# HIDDEN CREEK LLC ADDITION TO SEDGWICK COUNTY, KANSAS

RE: SUB 2003-137 -- One-Step Final Plat of Hidden Creek L.L.C. Addition

**CASE NUMBER:** SUB 2003-137 -- HIDDEN CREEK LLC ADDITION

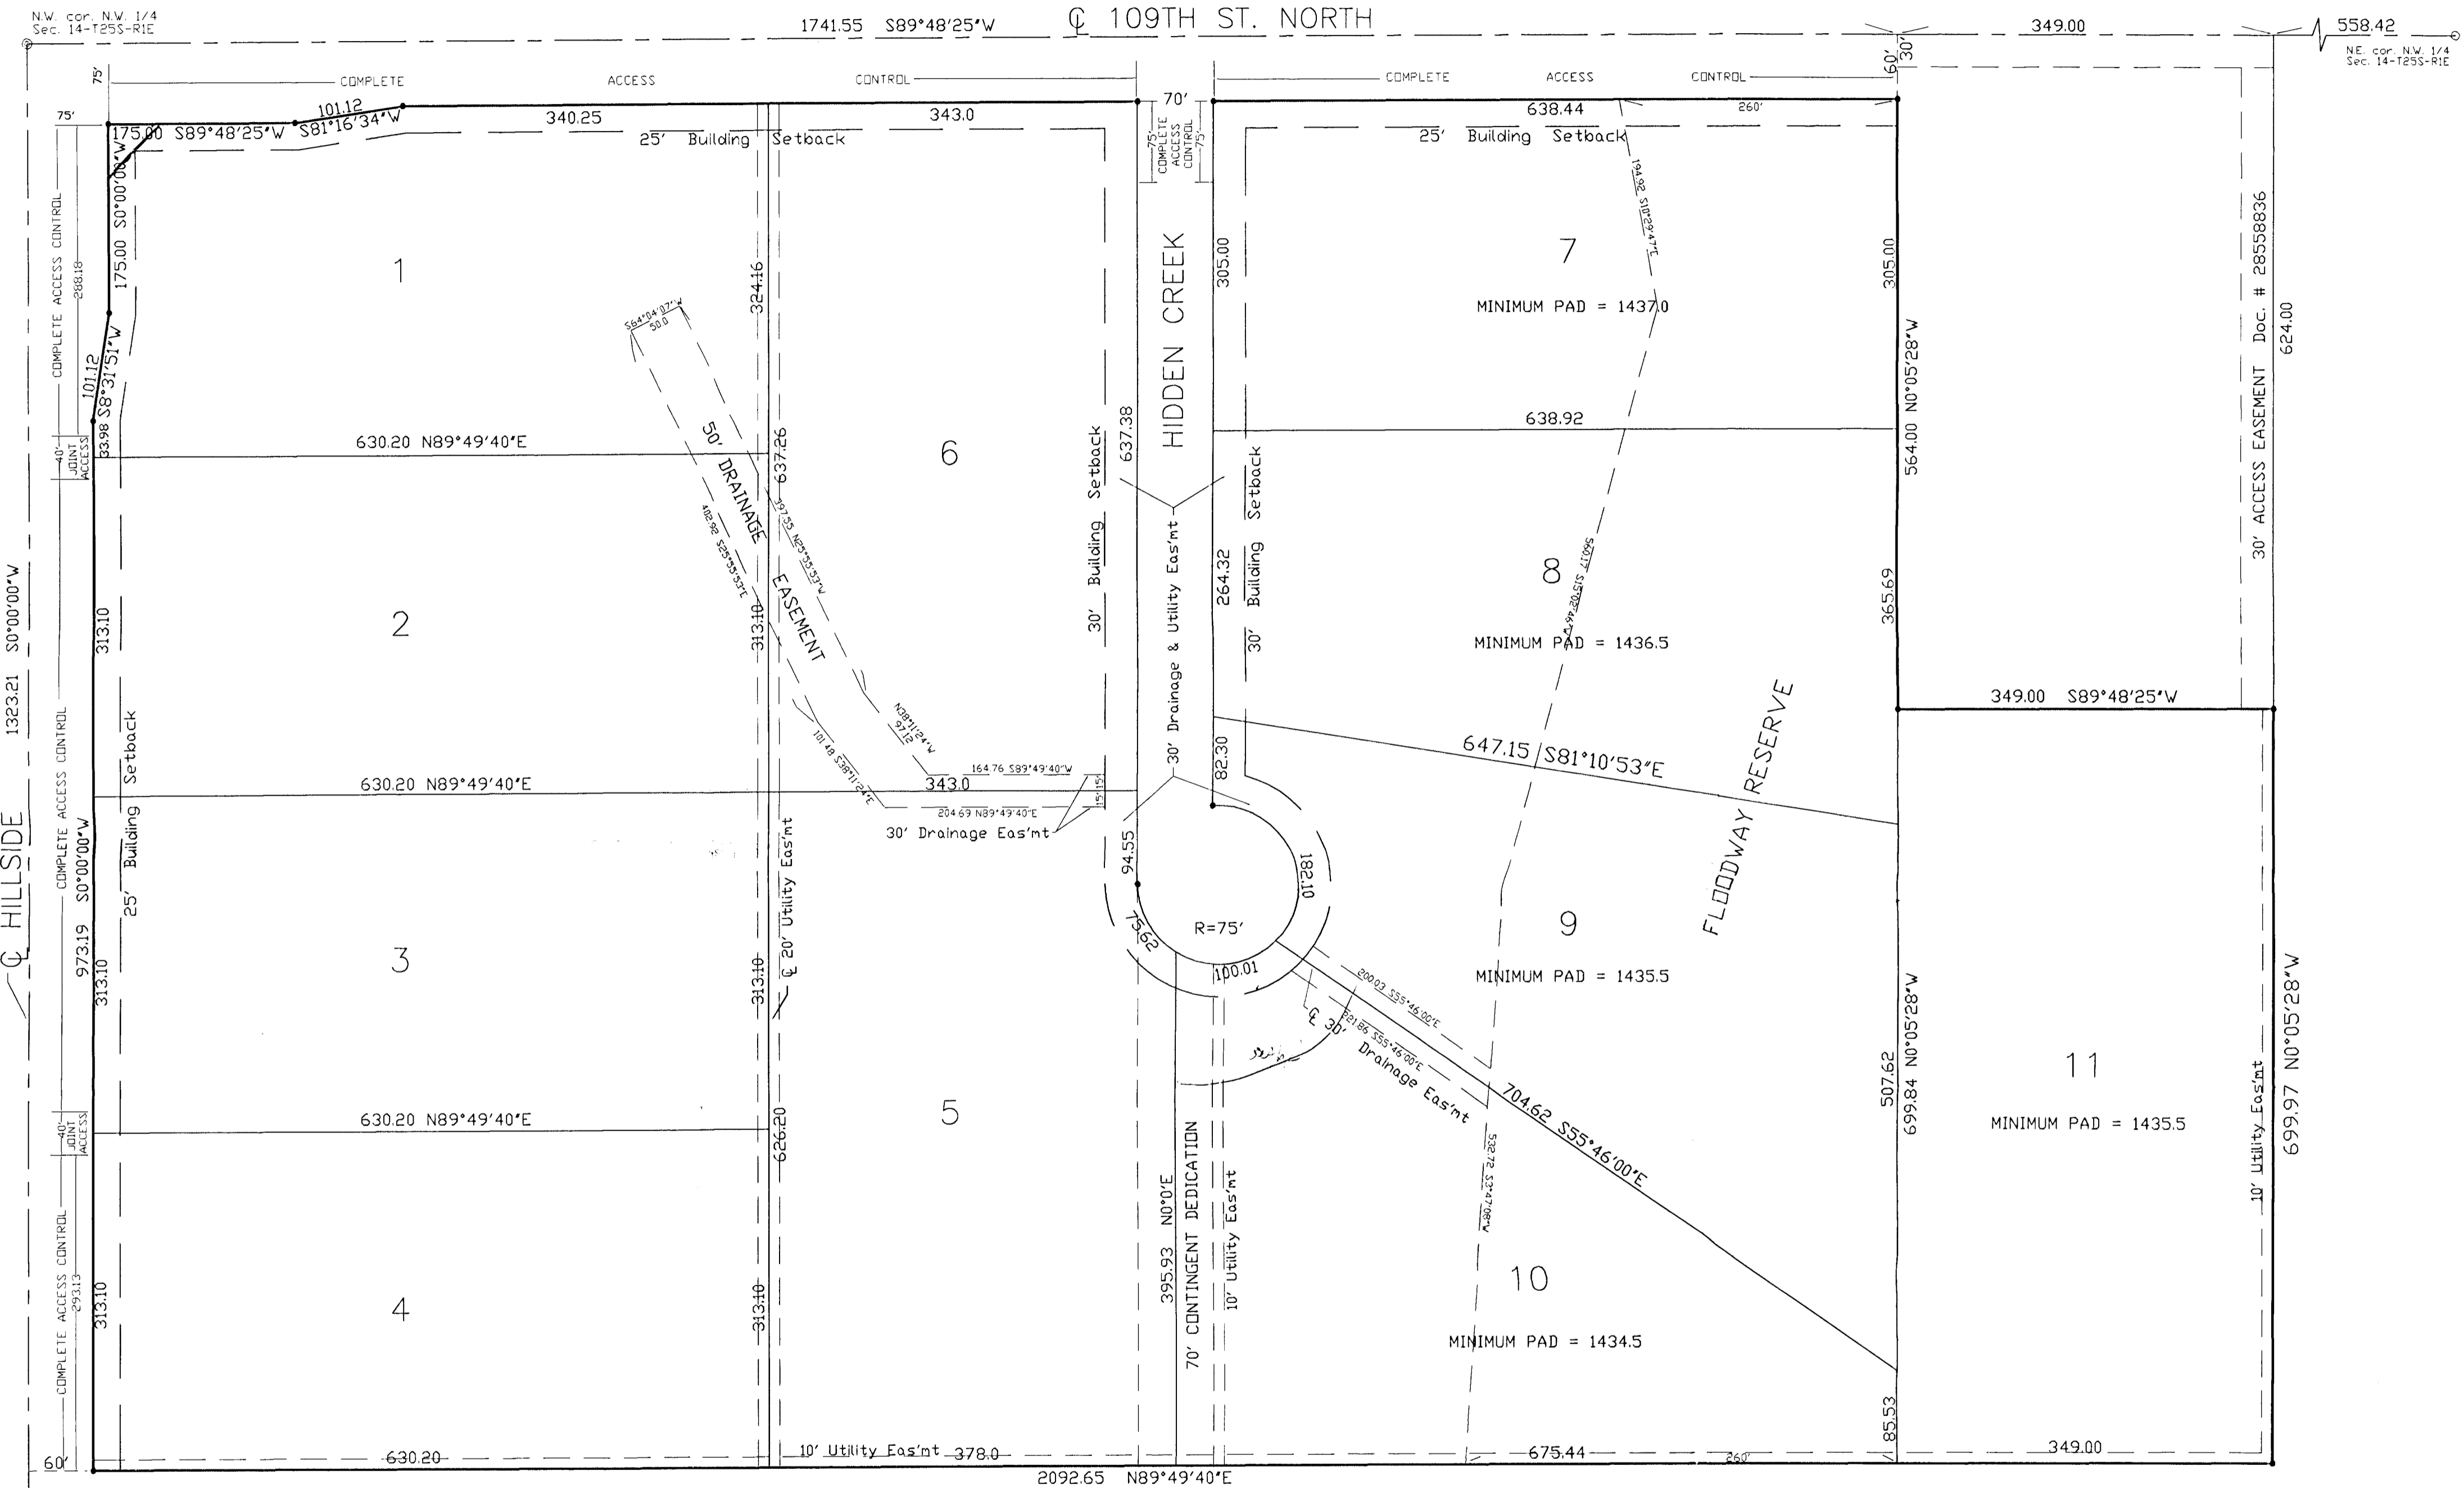
- D. **County Engineering** needs to comment on the status of the applicant's drainage plan. **A flood study and drainage plan are needed. Floodway reserves are needed.**

- G. In accordance with Access Management Regulations for County plats, complete access control is required for arterials intersecting with local streets. Complete access control of 75 feet is needed along Hidden Creek Ct from 109<sup>th</sup> St. North.

- H. **County Engineering** needs to comment on the access controls. The plat denotes two joint openings along Hillside. *County Engineering has approved the access controls. Dimensions of the access openings are needed. The appropriate arrows need to be included for the complete access control platted along 109th St. North. The plattor's text shall be corrected to reference "Lots 1-4" having access at two locations to Hillside.*

- J. In accordance with the Subdivision regulations for suburban subdivisions, the turnaround needs to be increased to a 75-ft property line radius.
- K. The Access Management Regulations requires a 60-ft half-street right-of-way width along rural arterials. The Regulations also requires an additional 25-ft x 25-ft corner clip at the intersection.

- L. The applicant shall guarantee the installation of the cul-de-sac to the 36-ft rock suburban street standard.
- M. In accordance with the KS Wetland Mapping Conventions under the Memorandum of Understanding between the USDA-NRCS; USEPA; USACE; and USF&WS, this site has been identified as one with potential wetland hydrology. The US Army Corps of Engineers (USACE) should be contacted (316-322-8247) to have a wetland determination completed."

- N. The Applicant is advised that if platted, the building setbacks along Hidden Creek Ct must be 30 feet to conform with the Zoning setback standard for the RR, Rural Residential District.

- O. Lot 10 does not conform with the 200-ft lot width standard which is measured at the building setback line. An increase in the distance of the building setback from the road would meet the standard.

- P. Approval of this plat will require a waiver of the lot depth to width ratio of the Subdivision Regulations for Lot 9. The Subdivision Regulations state that the maximum depth of all residential lots shall not exceed 2.5 times the width.

- Q. **GIS** needs to comment on the plat's street names. Hidden Creek Ct needs revised to "Hidden Creek".
- R. The Applicant should consider submitting the final plat with a revised name as an Addition now within Wichita exists with the name "Hidden Creek Addition".

- S. For lots fronting on cul-de-sacs, the lot frontage is required to be 50% of the required lot width (200 feet). Lot 10 does not meet this 100-ft frontage requirement.

- CC. The representatives from the utility companies should be prepared to comment on the need for any additional utility easements to be platted on this property. Westar Energy and SBC requests additional easements. Subdivision Committee also requested urban scale utility easements.
